REMARKS

Drawings

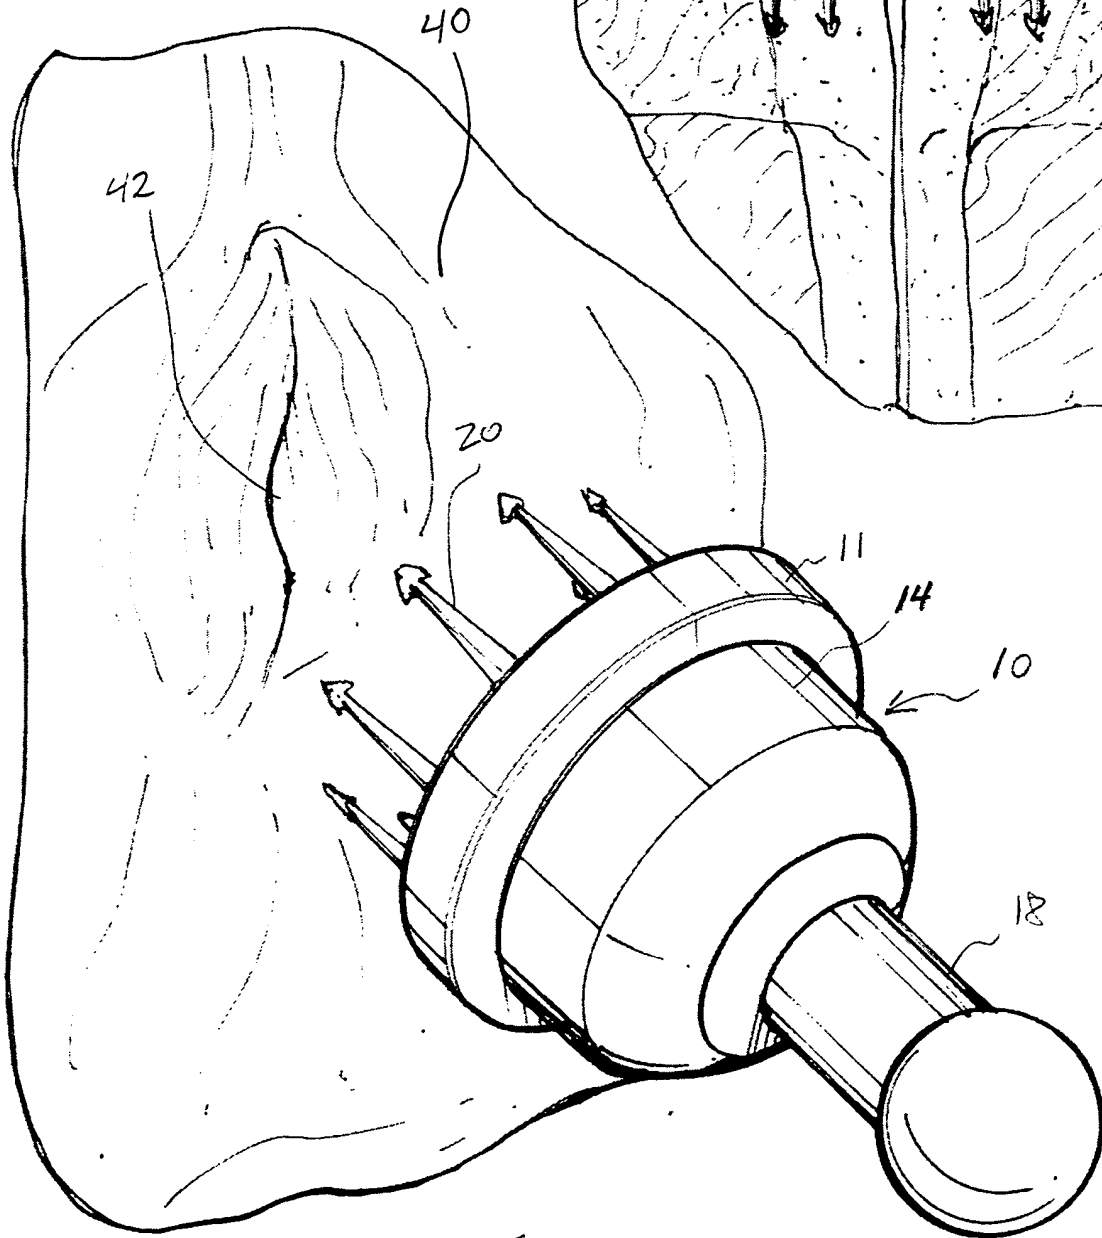
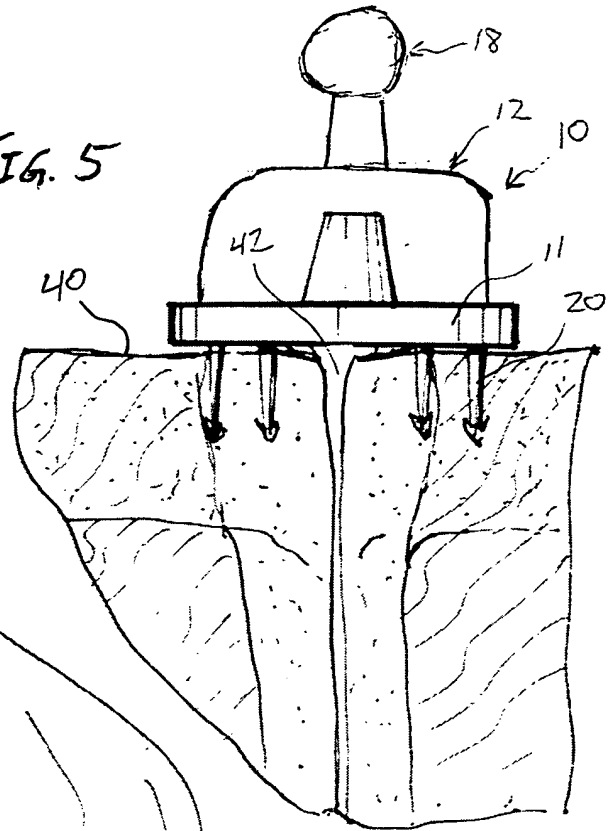
A replacement sheet including FIGS. 4 and 5 are included herewith. Reference numeral 40 indicating uterine tissue has been added as it was unintentionally omitted in the original. The reference numeral 40 is present in the specification on page 11 line 18.

Withdrawal of the objection to the drawings is respectfully requested. Specifically, the Examiner states that the "barbs" claimed in claims 4 and 14 are not illustrated. Applicant points out that the drawings and description show and describe a "barbed head 24". It is believed that a barbed head includes barbs and is adequately shown and described.
